PLANNING REPORT - Major Site and Building Plan Review and CUP

RE: Sunfish Lake – 2154 Charlton Road – Major Site and Building Plan Review
and Conditional Use Permit

Nelson
Home Addition and Renovation
2154 Charlton Road, Sunnyside Lake, MN 55118

A2.1

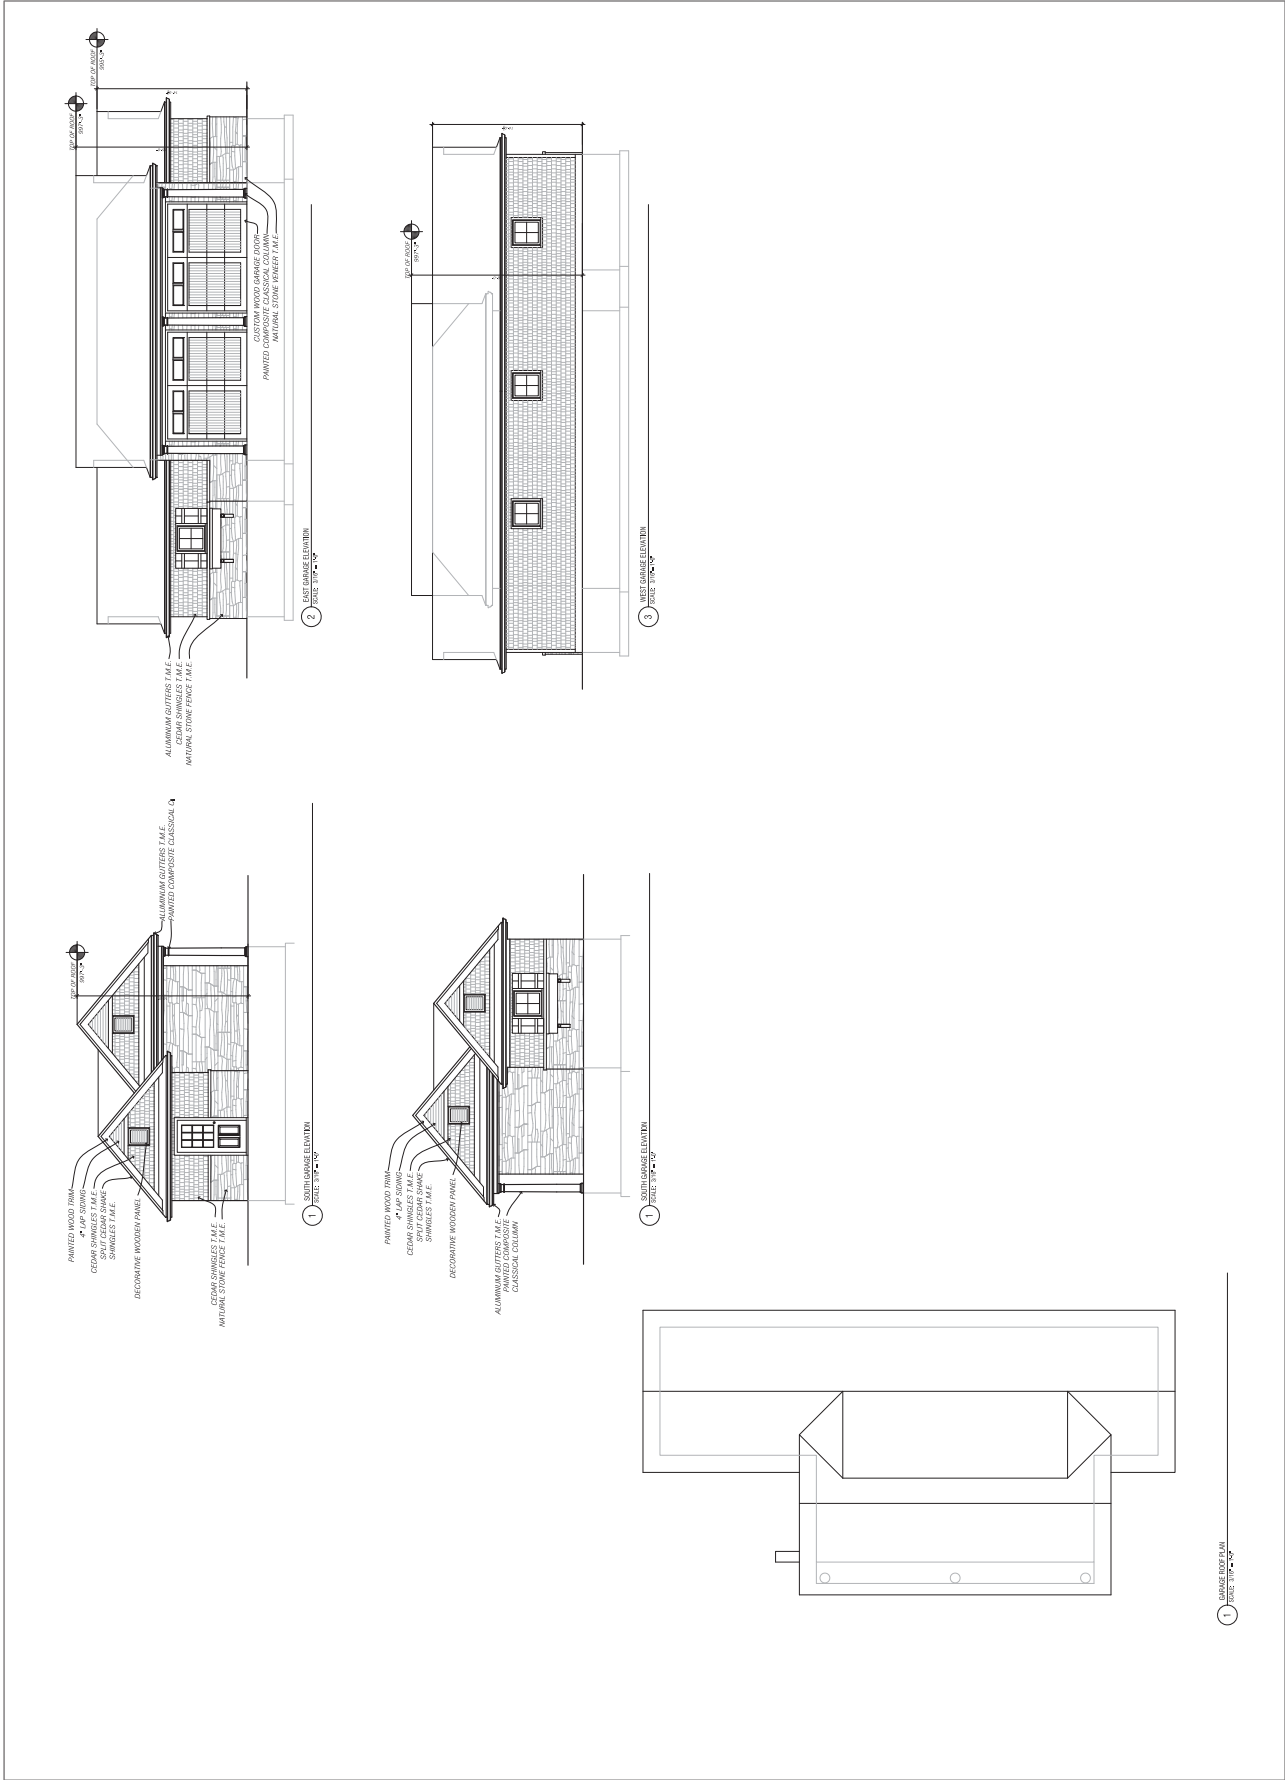
A detached garage is also being proposed by the applicants. Zoning Ordinance *Section 1217.01* allows detached accessory buildings not exceeding one story or 16 feet in height. The proposed detached garage is one story and approximately 16 feet in height, meeting ordinance standards for accessory buildings.

Accessory Buildings. An attached garage not exceeding 1,250 square feet (first floor) shall be considered an integral part of the principal building. With the proposed first floor additions the attached garage will total less than 600 square feet in area, which meets ordinance size requirements. In addition, the applicants are proposing to construct a detached garage approximately 820 square feet in area. Accessory ordinance permits detached accessory buildings up to 1000 square feet in area, in which case the proposed garage conforms to accessory structure design standards. However, accessory ordinance states that no permit shall be issued for the construction of more than one accessory structure except by conditional use permit. The subject property also contains an existing swimming pool, which is likewise considered an accessory structure in a single family residential setting. As such, the applicant is required to apply for a conditional use permit to construct a second accessory structure in the form of a detached garage on the parcel. A review of conditional use permit criteria in relation to the proposed detached garage will be provided later in the report.

Staff response. The existing attached garage will be reduced in size by approximately 25 square feet, and will be reduced from a three stall garage to a two stall garage. The applicants are requesting permission to build a detached garage to supplement the attached garage to provide additional space for storage of family vehicles and single family residential related supplies and equipment. *Section 1241.04* of the R-1 Single Family Residential District Ordinance permits accessory uses and structures for the storage of domestic supplies and equipment, and further permits accessory structures incidental and directly related to permitted uses in the district.

BENNER LARGE WALL SCONCE

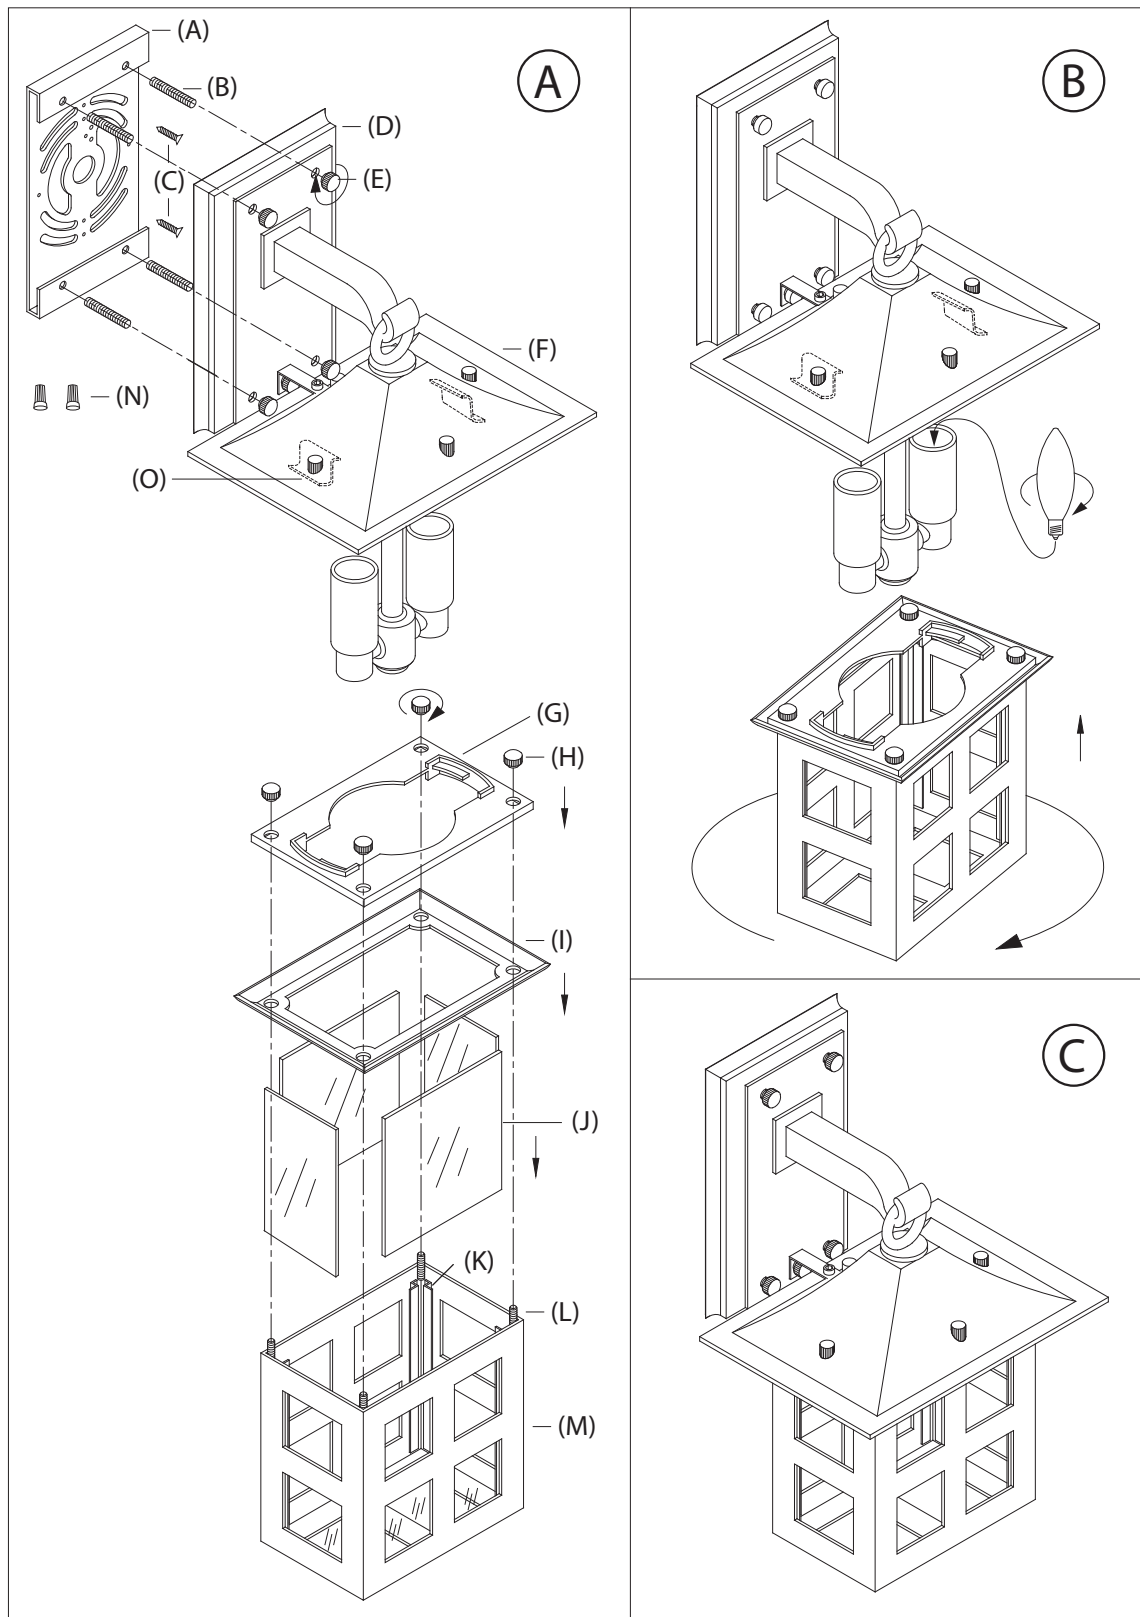
The applicants' exterior lighting plan includes five recessed Halo H7 ICAT LED down lights, located around along the front of the attached and detached garages and a new door opening on the north side of the home, one Benner large wall sconce, located beneath the new covered entryway, and two Benner small wall sconces, located on the south side of the new detached garage. All proposed lighting fixtures are hooded or recessed, and are not anticipated to be overly visible from adjoining properties or the lake. Upon installation, all lights or combination of lights which cast any light on residential property or over public water shall not exceed one foot candle (meter reading) as measured from the edge of water abutting the subject property. This may be demonstrated by providing evidence of at which distance out from proposed light fixtures meter readings will fall below the required one foot candle measurement.

3. Upon completion of installation of lights, all lights which cast any light on residential property or the lake shall not exceed one foot candle (meter reading), as measured from adjacent property lines and the shoreline.
